# Lower Thames Crossing 1.6 The Errata Report (Clean version)

DATE: December 2023 DEADLINE: 8

Planning Inspectorate Scheme Ref: TR010032 Application Document Ref: TR010032/APP/1.6

## 1.6 The Errata Report (Clean version)

# Appendix A HRA Figure 24

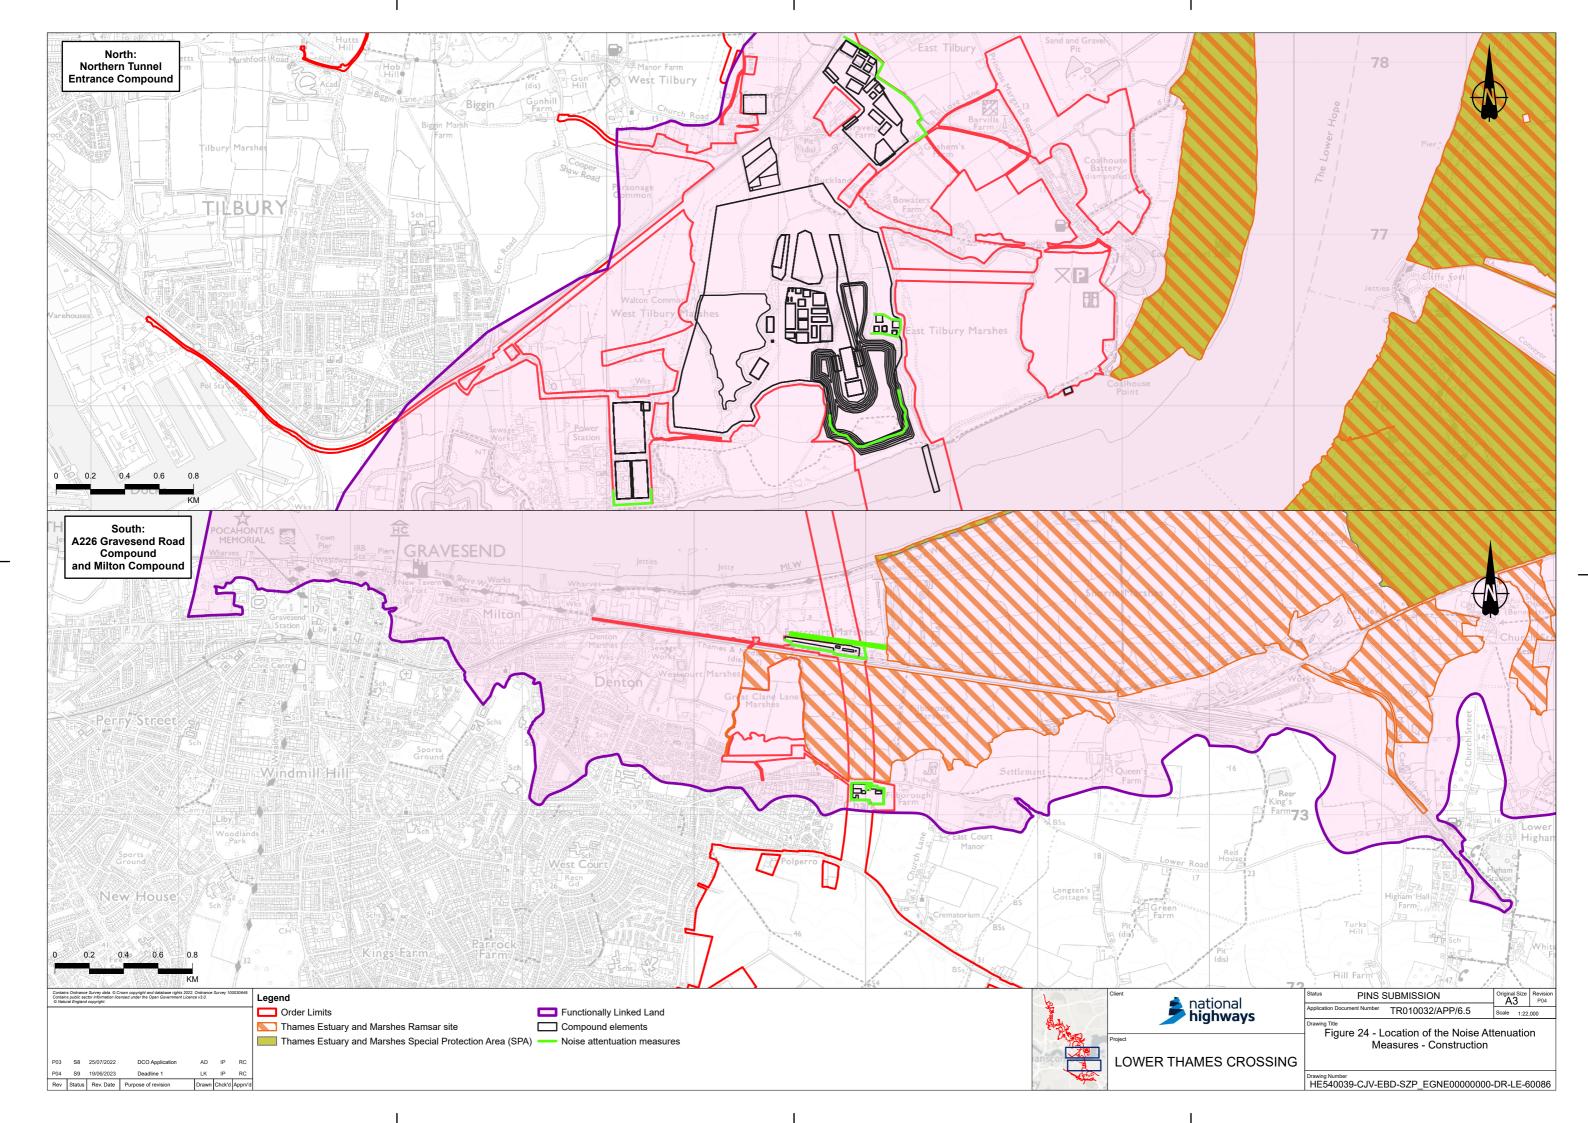
APP-487	S51 Dec 2022	Habitats Regulations Assessment Screening Report and Statement to Inform an Appropriate Assessment	Appendix A Figure 24	North view not showing all of noise attenuation measures	North view rescaled to show all noise attenuation measures	Figure updated and found in Appendix A of this document.
APP-487	D1	Habitats Regulations Assessment - Screening Report and Statement to Inform an Appropriate Assessment	Figure 24	Figure missing	Figure is cut off and does not include the full extent of proposed construction noise barriers	Figure updated and found in Appendix A of this document.
APP-495	D3	Planning Statement	Paragraph 5.3.24	Туро	Paragraph says "model provision." Should state "modal provision."	No change, Document not updated at this time.
